CITY OF MERCED PROJECT NO. CP220069 CHANGE ORDER NO. 1

PROJECT NAME: Laura Fountain Repair

REASON FOR CHANGE ORDER: Revision to materials to be used and work required for fountain removal. Proposed fountain liner material (Bid Item # 14 New Fountain Gunite" will be substituted for a more suitable material called Shotcrete. It was also determined that the fountains foundation was in good condition so the fountain itself did not require to be removed and replaced. This results in a savings for bid items 5 "Remove Fountain" & bid item 12 "Install Fountain". Bid item 5 "Remove Fountain" included the fountain walls, so savings includes 2/3 of that item total cost (1/3 was applied towards the fountain walls). Also added fountain lights for illuminating the fountain. See description of change below.

Proposed Change Order #1 Addition of Submerged LED Lighting

UNDERWATER LIGHTS SL-33 SERIES

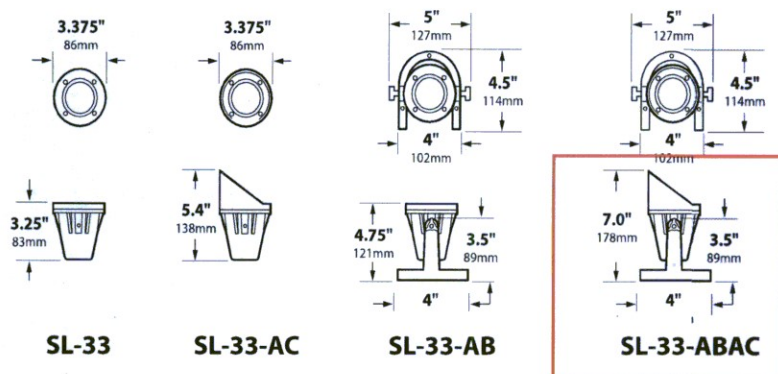
To provide nighttime illumination of the fountain and improve public safety we are proposing the installation of 8 LED lights to illuminate the marble elements and water flows. The installation includes 8 lights, one flush mount junction box, cord seals, interconnecting conduits, wiring, potting of junction boxes, and a timer/transformer.
